**REQUEST**

Current Zoning: R-3 (single family residential)  
Proposed Zoning: R-8MF(CD) (multi-family residential, conditional)

Approximately 20.88 acres located along the southeast side of Mallard Creek Road and north of Morris Estate Drive.

The petition proposes to allow up to 130 townhouse style dwelling units for a density of 5.7 dwelling units per acre on vacant land.

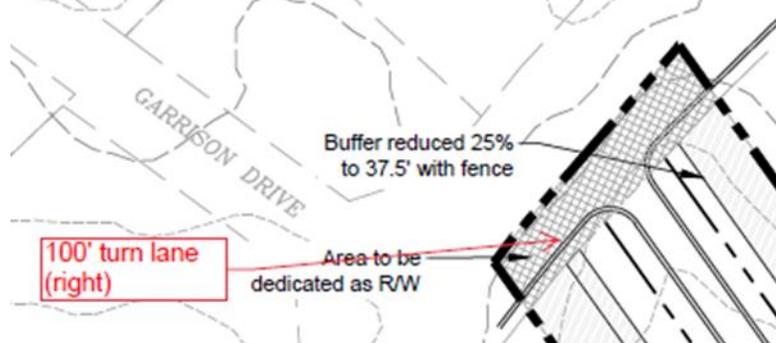
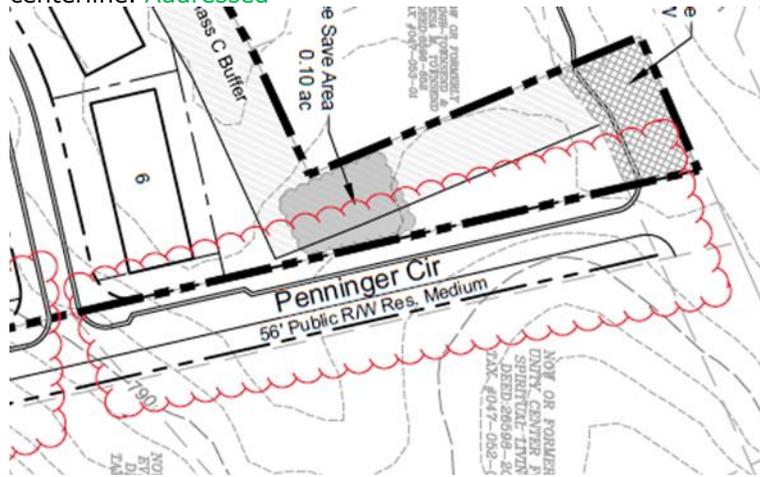
1. ~~The petitioner should revise the site plan to include the roadway improvements that will be constructed within NCDOT's STIP (#U-2507A). In accordance with Charlotte BIKES, please provide an 8-foot planting strip and a 12-foot multi-use path, if sidewalk is not constructed within the STIP. Addressed~~
2. ~~The petitioner should revise the site plan and conditional note(s) to confirm adequate intersection sight distance, according to CDOT's Sight Distance Policy, for access proposed on Mallard Creek Road. Addressed~~

3. ~~Technical Clarification (site plan dated 09/14/20) The petitioner should clarify conditional note (Section 3.G.) that 2-ft of additional right-of-way should be dedicated from back of the 12-ft multi-use path. The petitioner should construct a 12-ft multi-use path where the existing sidewalk is removed for the proposed right turn lane. Where the existing sidewalk remains undisturbed along the property frontage, CDOT requests for the existing sidewalk to be widened to 12 ft, in accordance with Charlotte BIKES. Addressed~~

4. ~~Technical Clarification (site plan dated 09/14/20) The petitioner should clarify whether front-loaded or rear-loaded units are proposed. If front-loaded, the petitioner should commit to pair shared driveway aprons with every two units, to preserve the proposed planting strip and sidewalk within the public right of way. This request limits the number of curb cuts, and promotes walkability, and preserves a quality streetscape. Addressed~~

5. ~~Technical Clarification (site plan dated 09/14/20) The petitioner should clarify conditional note (Section 3.D.) that a proposed right turn lane will be constructed at the proposed Mallard Creek Road right in/right out access. The proposed right turn lane should have 100-linear feet of storage with the appropriate bay taper length, according to NCDOT design standards. Addressed~~

6. ~~Technical Clarification (site plan dated 09/14/20) The petitioner should clarify the site plan to show and call out the existing Penninger Circle private drive that ties into existing Mallard Creek Road. CDOT requests the petitioner to clarify that the existing Penninger Circle road~~

improvements will be constructed in accordance with CLDSM U-02—Local Residential Medium Section cross section design standards, on both sides of the existing Penninger Circle road centerline. Addressed
